Marin County Flood Control and Water
Conservation District
**Corte Madera Creek Flood Risk Management
Project, Phase 1**
Final Environmental Impact Report
Volume 1: Comments and Responses to Comments
State Clearinghouse No. 2020080353

**Marin County Flood Control and Water
Conservation District
Corte Madera Creek Flood Risk Management
Project, Phase 1
Final Environmental Impact Report
Volume 1: Comments and Responses to Comments
State Clearinghouse No. 2020080353**

Figure 2-17 Alternative 1 Changes in Water Surface Elevation Year 2100, 100-Year Flood Event (Upper Corte Madera Creek)

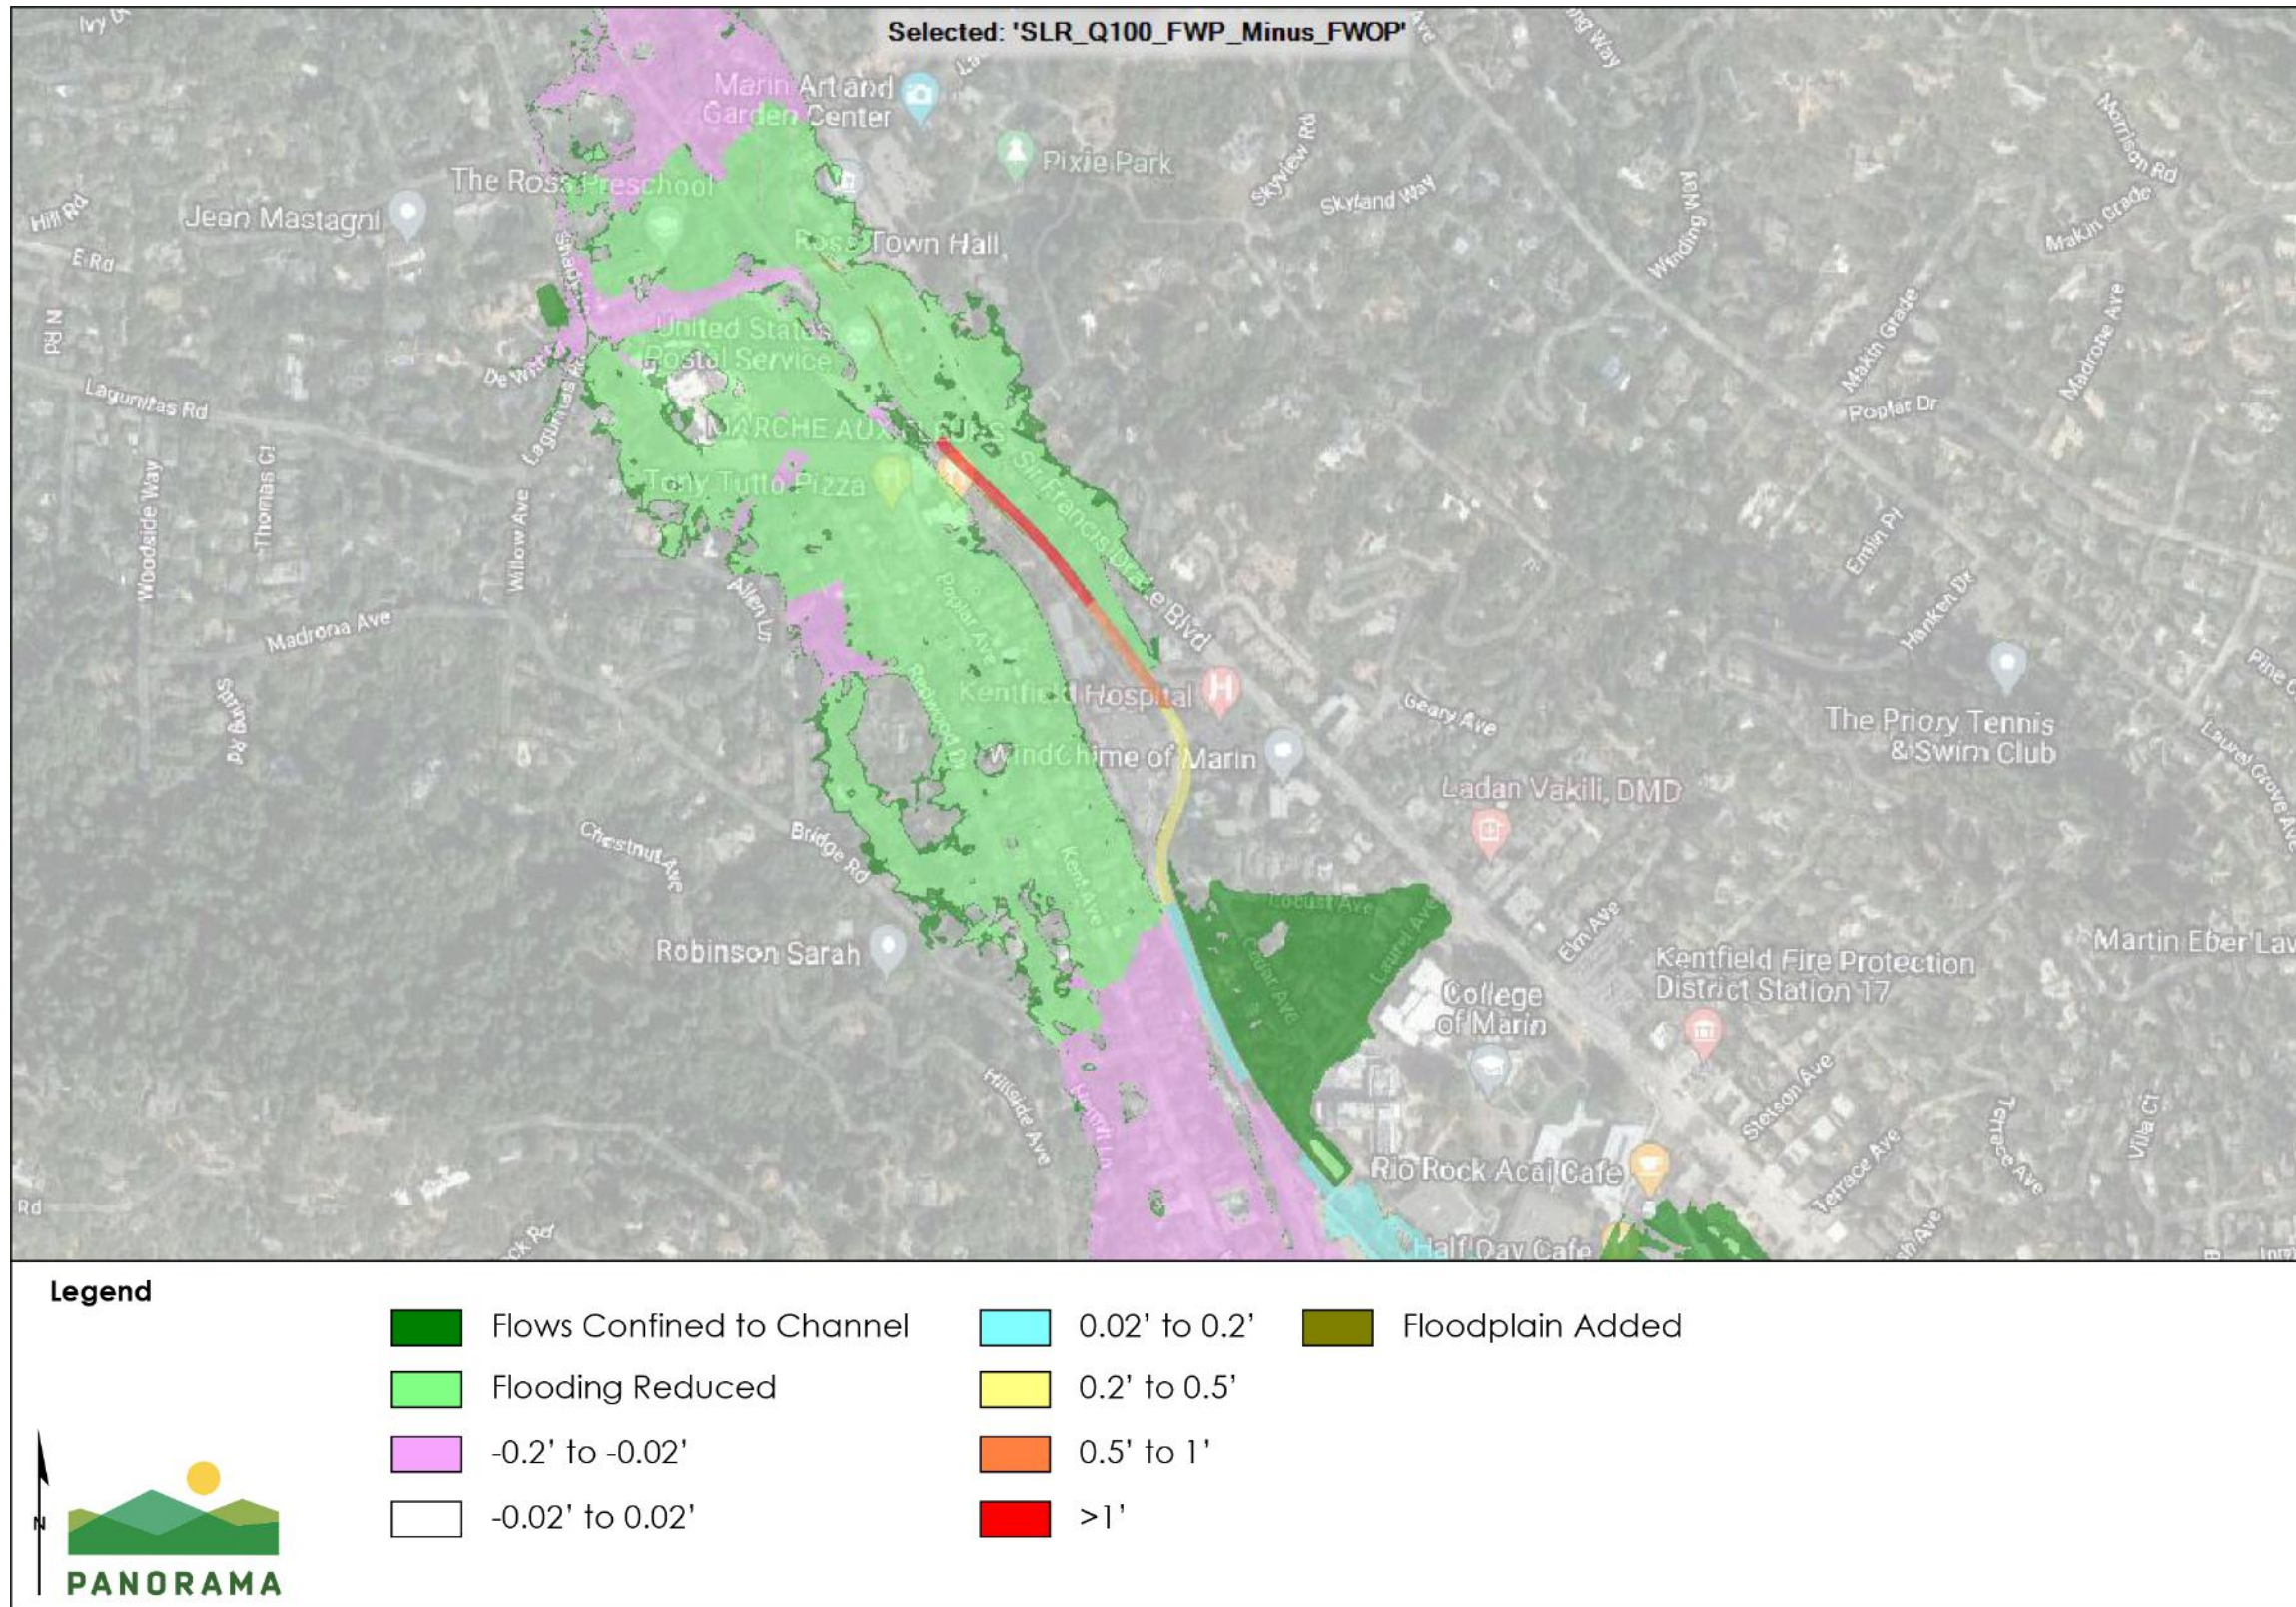
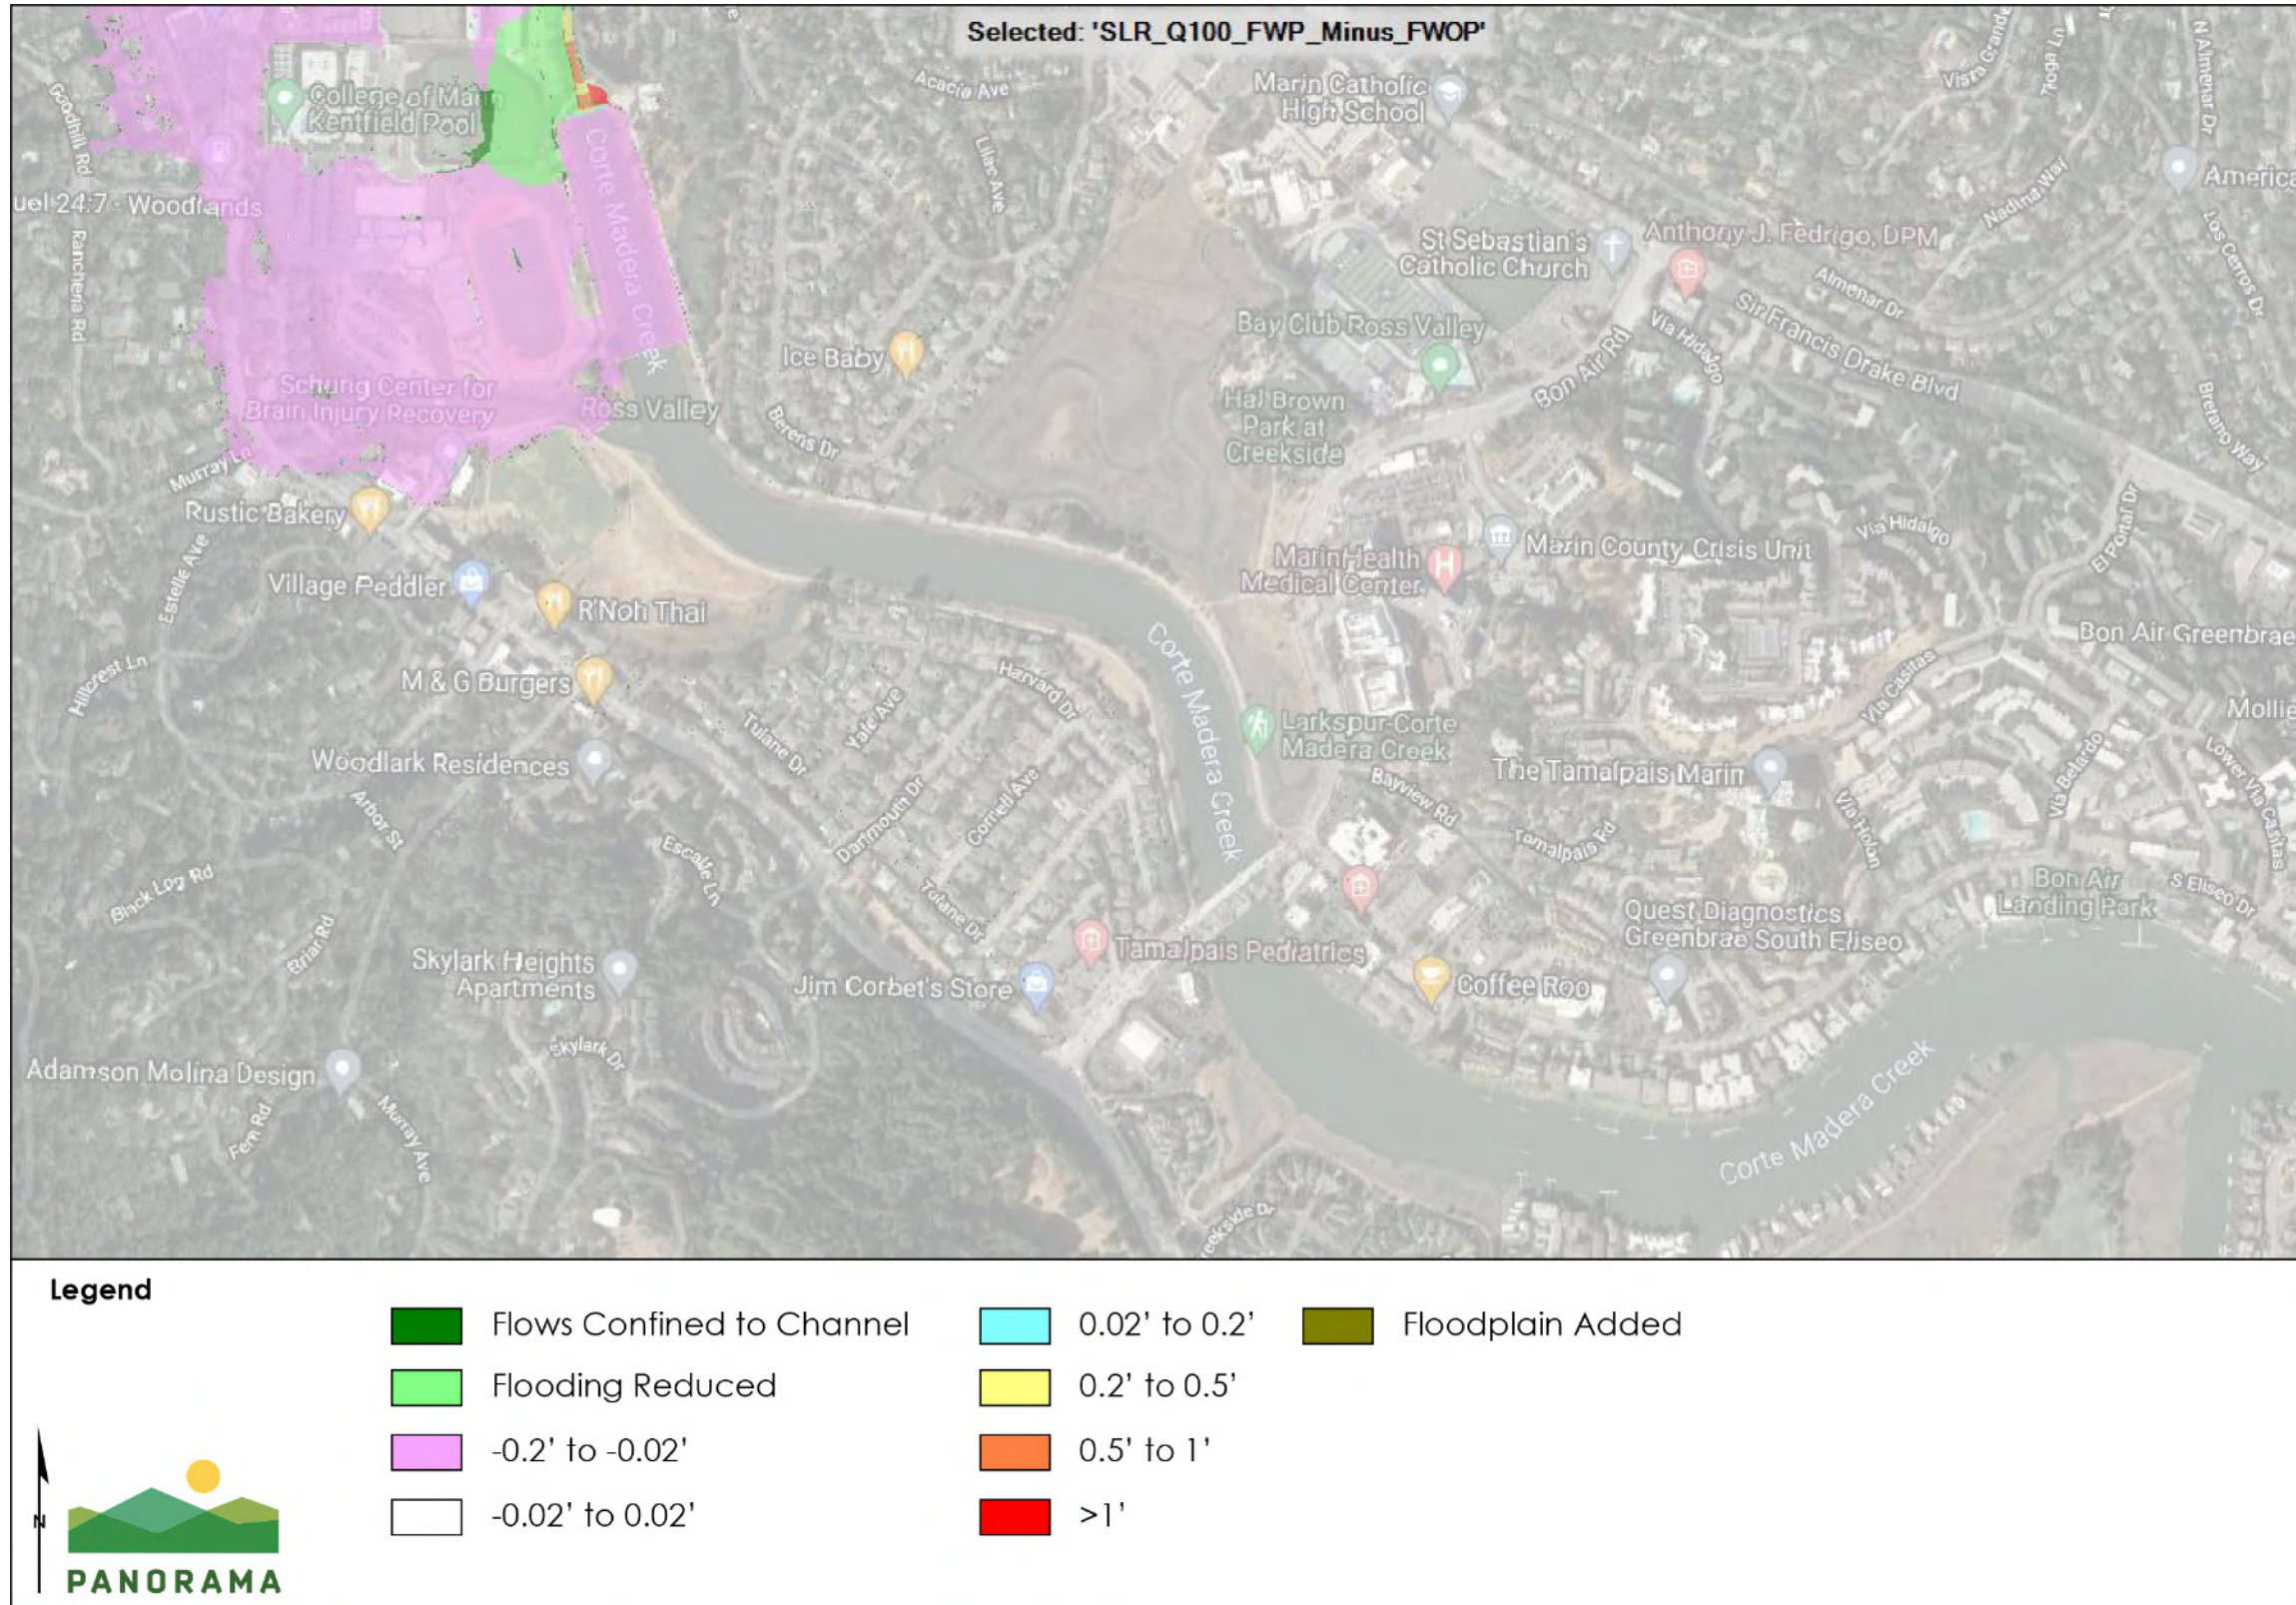
The geographic extent of the figures showing the changes in WSE differs from the figures included in the Draft EIR. The geographic extent of the figures was expanded to show areas downstream from Unit 2 in response to comments from the City of Larkspur. As discussed on page 3.9-39 in the Draft EIR, a threshold of 0.2 foot (2.4 inches) was used for determining whether a potentially significant increase or decrease in WSE would occur at any structure. The 0.2-foot threshold is a reasonable level of precision for evaluating flooding impacts, considering the standards for accuracy and precision associated with hydraulic modeling.

Figure 2-1 through Figure 2-6 show the Alternative 1 changes to the WSE and reflect the difference in WSE between the Existing Condition Without Project and Existing Condition With Alternative 1 scenarios under a 10-, 25-, and 100-year flood, using the updated modeling for the 60 percent design. Figure 2-7 through Figure 2-12 show the Alternative 1 changes to the WSE under for the future condition scenario, and reflect the difference in WSE between the Future Condition Without Project and Future Condition With Alternative 1 under the 10-, 25-, and 100-year flood conditions. The assumptions used in the future condition modeling are described on pages 3.9-35 through 3.9-37 in Section 3.9 in the Draft EIR and are supplemented by the model updates described above. Figure 2-13 through Figure 2-18 show the Alternative 1 changes to the WSE under a “high-emissions likely” sea-level rise scenario, to reflect 2100 projected sea-level rise based on the 2018 Update of the State of California Sea-Level Rise Guidance (California Ocean Protection Council, 2018). Figures 2-13 through 2-18 reflect the difference in WSE between the Year 2100 Future Condition Without Project and Year 2100 Future Condition with Alternative 1 scenarios under the 10-,25-, and 100-year flood conditions.

Areas shown in the figures as “Flows Confined to Channel” are areas that are currently flooded by Corte Madera Creek, which are predicted to no longer have flood inundation from Corte Madera Creek overtopping after Alternative 1 is implemented. Areas shown in the figures with “Flooding Reduced” are areas with reduced flood inundation (greater than 0.2 foot) from creek overtopping after Alternative 1 is implemented. The change in WSE shown on the maps reflects a comparison between WSE without implementation of Alternative 1 and the WSE after implementation of Alternative 1 for each modeled scenario.
